#### Re: Defect Information Report – Supplemental Report No. 1 11V-283, FL-607, Western Star Airlines Interim Notification

August 2011 FL607 NHTSA #11V-283 Transport Canada #11-196 INTERIM RECALL BULLETIN

### **Subject: Western Star Airlines**

#### Models Affected: Specific Western Star 4900 vehicles with a standard cab height and a Detroit Diesel DD13 engine manufactured April 1, 2010, through May 13, 2011.

Fig. 1

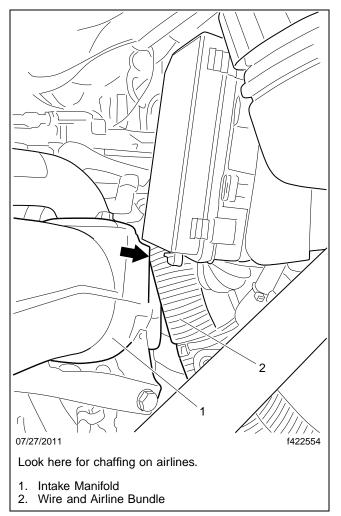
- 1. Park the vehicle on a level surface, shut down the engine, and set the parking brake. Chock the tires.
- 2. Open the hood.
- 3. Inspect the airlines and wire harnesses between the PDM and the air intake manifold in the area indicated in Fig. 1.

If there is evidence of chaffing or the lines are within 0.75 in (19 mm) of the intake manifold, take the vehicle to an authorized Daimler Trucks North America dealership for repair.

- 1. Park the vehicle on a level surface, shut down the engine, and set the parking brake. Chock the tires.
- 2. Open the hood.
- 3. Inspect the airlines and wire harnesses between the PDM and the air intake manifold in the area indicated in Fig. 1.

If there is no chaffing and adequate clearance (0.75 in (19 mm) or more from the intake manifold), no action is needed.

If the lines are within 0.75 in (19 mm) of the intake manifold (and the lines are not chaffed), loosen the tiestraps as needed and relocate the lines so they are at least 0.75 in (19 mm) from the manifold. Then secure the lines in the new position with tiestraps.

If there is evidence of chaffing, replace the airlines as needed.
